Southern California Edison
WODUP A.13-10-020

DATA REQUEST SET A.13-10-020 WODUP ED-SCE-10

To: ENERGY DIVISION
Prepared by: Scott Lacy, P.E.
Title: Project Engineer
Dated: 12/05/2014

Question ALT-17c:

WEST OF DEVERS PROJECT
SEGMENT 4 CROSS SECTION NO.5

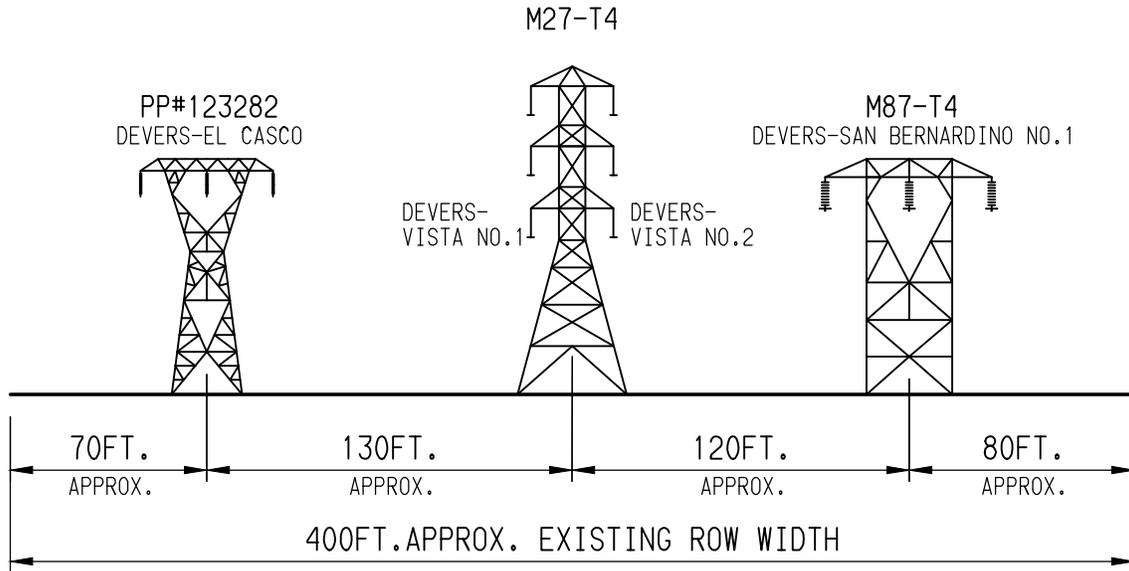
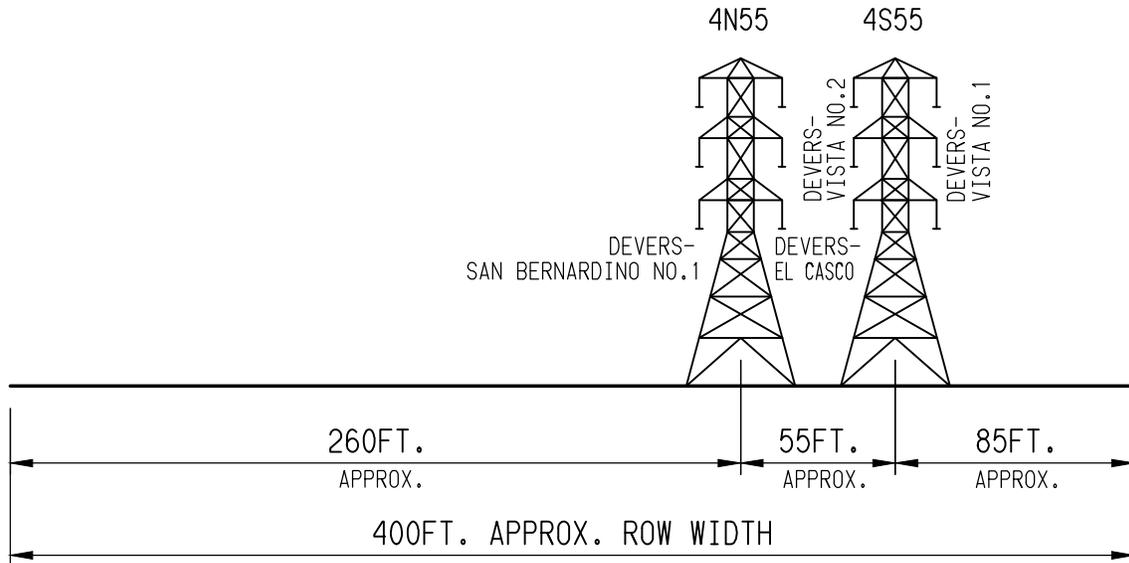
Follow-up to ALT-15 (Data Request No. 7, regarding potential Tower Relocation): SCE's response to ALT-15(a) stated the current locations of proposed towers "have been determined based on not only the need to reserve the largest possible amount of ROW available for future expansion, but also to be placed in locations that would allow for the most efficient and safe working environment for the construction of these new towers in close proximity to the existing lines that operate through that corridor."

(C) SCE's response to ALT-15 states "If the new tower lines were to be redesigned farther north, to allow for added separation from the southern edge of the ROW, the construction of the northern tower would impinge within the safe working distance away from the existing double-circuit tower line that runs along the north side of Segment 6 and the center of Segment 4. The construction efforts necessary for that tower placement would therefore be significantly extended, because SCE would have to initially build the new southern tower line, string those two new circuits, and then return to the same areas again to perform similar construction activities, such as foundation construction, tower assembly and erection and line stringing, for the second (northern) tower line." What would be the minimum safe working distance from the existing double-circuit tower during construction of the new towers?

Cal-OSHA requirements (8 CCR Section 2946) require a 10-foot minimum clearance for personnel (Table 1) and a 17-foot clearance for cranes (Table 2). When combined with the 14-foot distance from the center of a typical double-circuit 220kV structure to the end of the crossarm and a 5-foot buffer to account for situations where new towers may be located mid-span in comparison to existing towers, it would be feasible to place the new northern structures no closer than 50 feet, center-to-center, away from (i.e., south of) the existing double-circuit structures ($14 + 14 + 17 + 5 = 50$).

As part of SCE's ongoing engineering efforts, the design distances from the southern right-of-way boundary to the southern tower have been increased through a portion of Segment 4 (essentially from Highland Springs Road to Interstate 10). The five cross-section drawings applicable to Segment 4 that were submitted in response to Data Request Set # 4, Question No. V-3 (dated 04/24/14) have been updated with the most current information and have been attached to this response for informational purposes.
